AUBURN HILLS 15TH ADDITION WICHITA, SEDGWICK COUNTY, KANSAS

RE: SUB 2003-122 -- One-Step Final Plat of Auburn Hills 15th Addition

STAFF REPORT
(One-Step Final Plat Approved 10/30/03)

CASE NUMBER: SUB 2003-122 -- AUBURN HILLS 15TH ADDITION

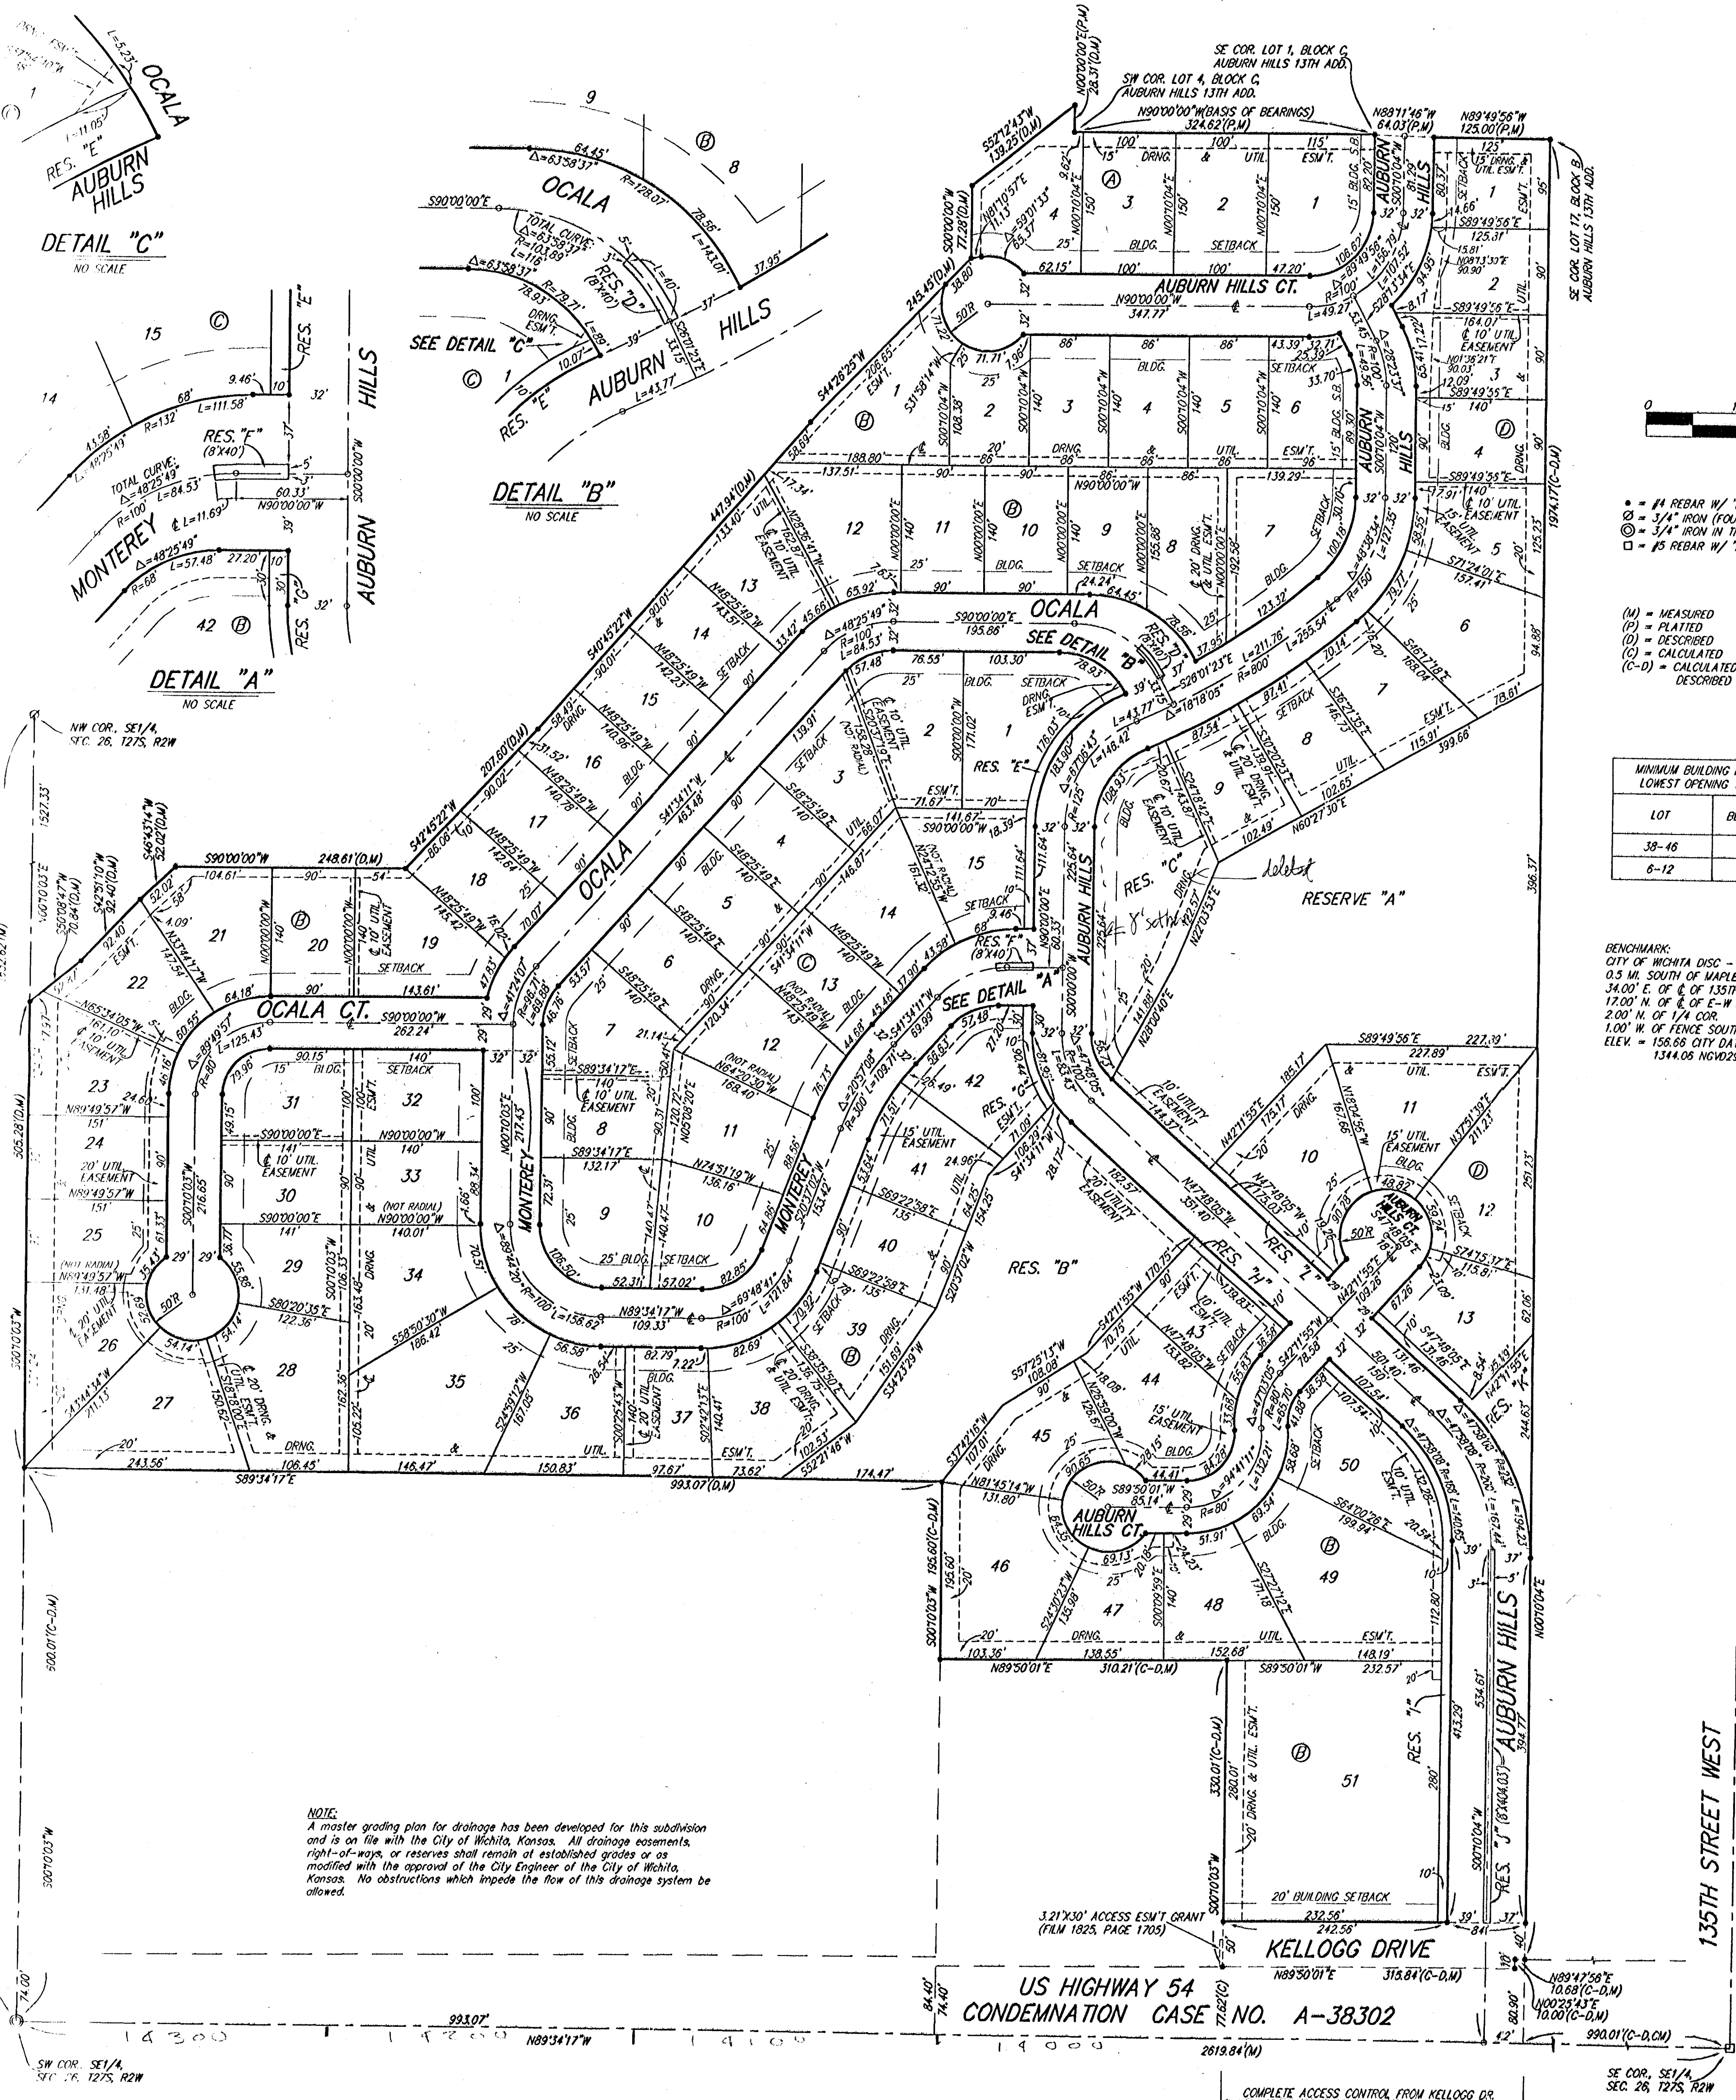
- A. This plat will be subject to approval of the associated zone change and any related conditions of such a change. Prior to this plat being considered by MAPC, the zone change will need to be approved. In the alternative, a restrictive covenant shall be submitted limiting this portion of the site to uses permitted in the SF-5 zoning district.

- D. City Engineering needs to comment on the status of the applicant's drainage plan. City Engineering requests additional information.
- E. The plat proposes a full movement intersection on Kellogg at a quarter-mile point on Kellogg. Traffic Engineering has advised that the City has worked with KDOT on an access management plan for the Kellogg Freeway that allows only signalized full movement intersections every half mile. The developer will need to obtain KDOT's approval for connection to Kellogg prior to development.

- F. The applicant is advised that the right-of-way width of Dogleg Cir may be revised to the 58-ft standard for cul-de-sac streets.
- G. The Applicant shall guarantee the paving of the proposed streets. The guarantee shall also provide for sidewalks on at least one side of all through, non cul-de-sac streets.

- H. As noted in the plat's text, the applicant intends to restrict the utilities to easements on Reserves A and B and therefore such easements should be platted in these reserves.

- M. The blocks need to be renumbered (dividing Block A into two blocks) as the perimeter of the blocks should be bounded by streets. Block D should be encompassed within Block A.

- N. GIS needs to comment on the plat's street names. ***The will be requesting that Dogleg in the adjacent plat to the north be revised to Auburn Hills by affidavit. The northernmost cul-de-sac shall be denoted as "Ct". Cross St. shall be assigned two new street names.***

- P. For any lots with existing tree rows that may be impacted by the installation of utilities, it is recommended that 30-ft utility easements be platted in order to allow for the installation of the utilities without damage to such tree rows.

- Y. The representatives from the utility companies should be prepared to comment on the need for any additional utility easements to be platted on this property. Westar Energy requests additional easements.
